## UPPER GROUND FLOOR

Prior to the sale of the property to a single purchaser, various conditions to the current Listed Building Consent, LPA Ref: 2016/6022/L, were discharged and the works undertaken.

In addition to the overall new proposals now sought for a single family dwelling, specific approval is sought for items under the current approval LPA Ref: 2016/6022/L, which required specific conditional discharge:

DRAWING  
Kidderpore Hall  
Level RF Proposed GA Plan

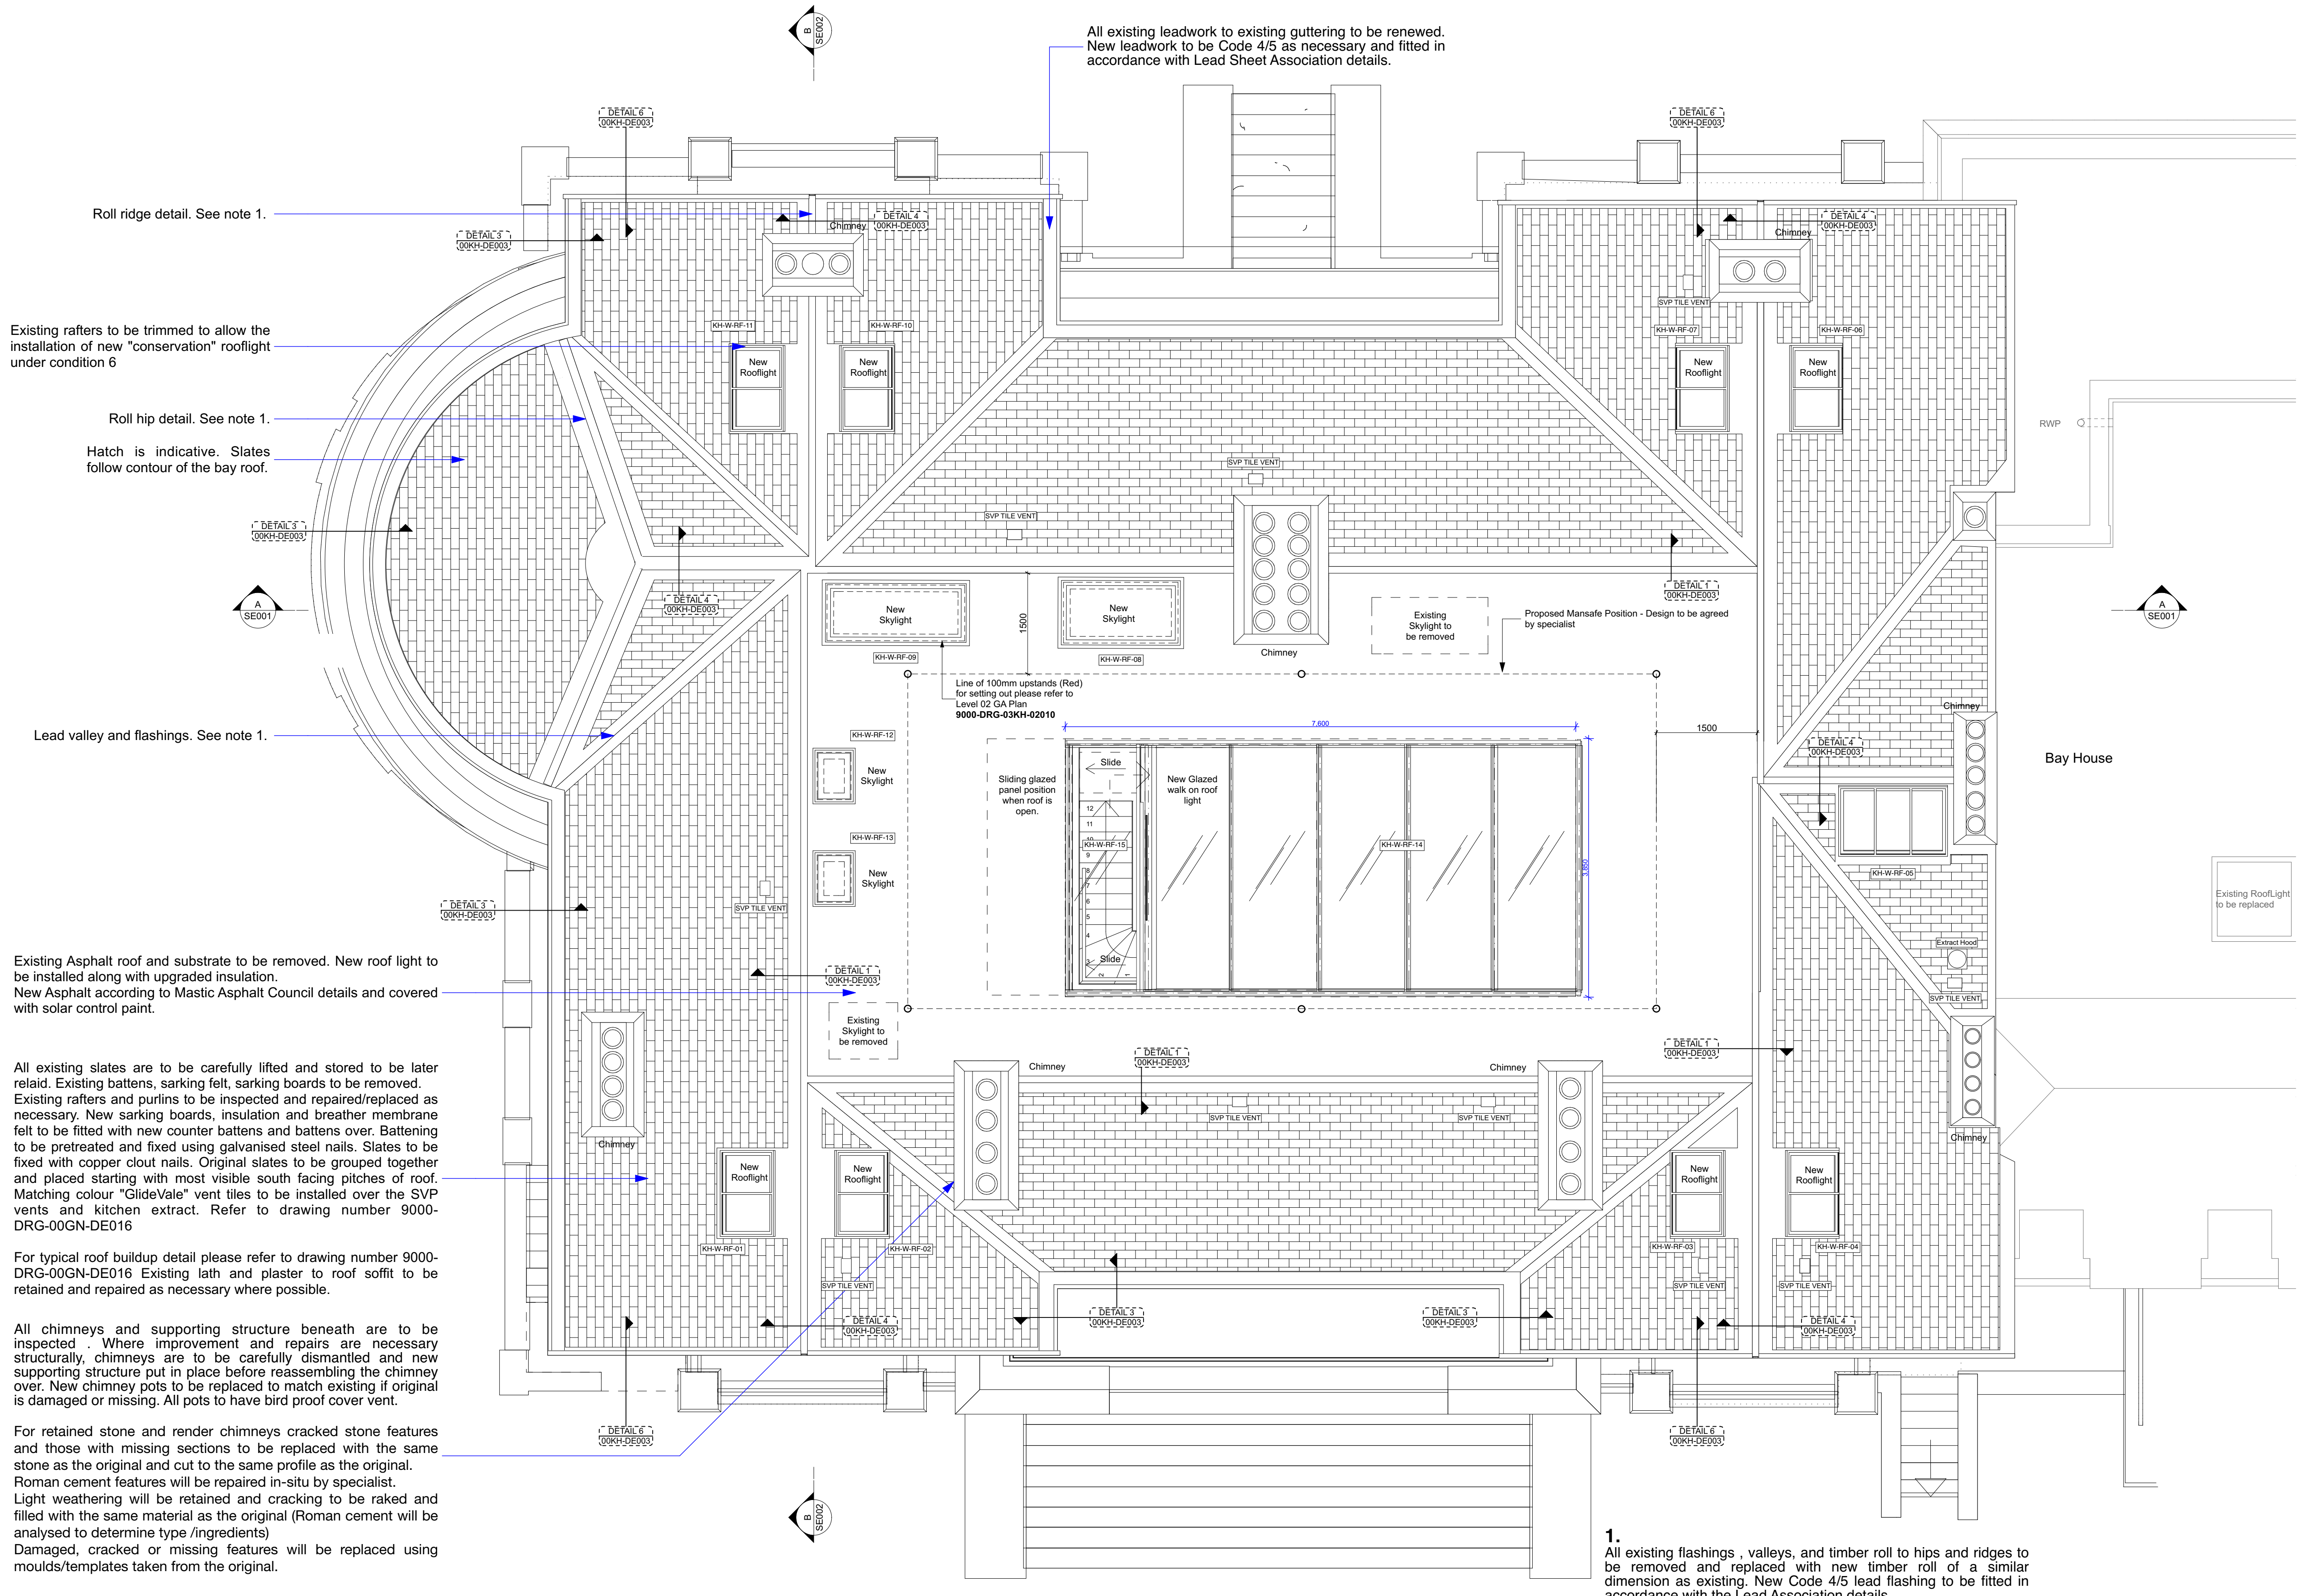
No change is proposed to the main works at roof level, which remains as the current approval. Locations for an aerial and satellite dish have been added towards the rear of the roof.
